**FCC Class II Permissive Change Application Letter**

Product name : EngiPlay Kit  
FCC ID: 2A6J8-EPK0011  
Date of Grant: 2024-10-11  
Model No.: EPK001-1

Change Contents: Update the components on PCB board and External as below:

Location	ExternalPhotos	InternalPhotos	Difference description
----------	----------------	----------------	------------------------

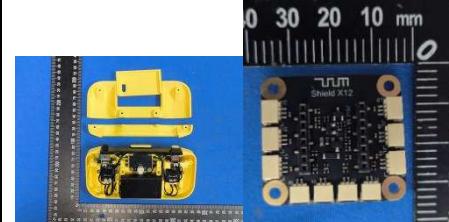
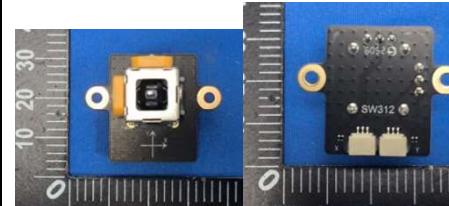
<p><b>Old PCB of FCC ID:</b> 2A6J8-EPK0011</p>			<ol style="list-style-type: none"><li>1) The evaluation distance of this device has been changed from fixed use to portable use, and SAR testing has been added. Please refer to the SAR testing report.</li><li>2) Compared to the original model, ZK001&amp;ZK002 have an additional matching casing, but the circuit board has no functional differences.</li></ol>
<p><b>New PCB of FCC ID:</b> 2A6J8-EPK0011 Model No.:ZK001</p>
